Rezoning Transportation Analysis

Petition Number: 2026-033

Date	Description
6-25-26	First Review (CM)

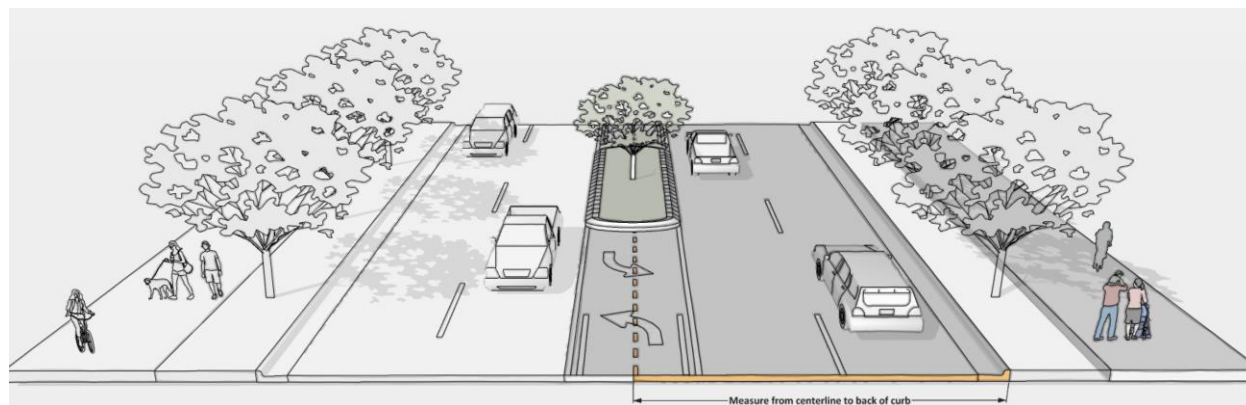
Petitioner to provide responses to the staff comments below as well as specify other changes to the site plan.
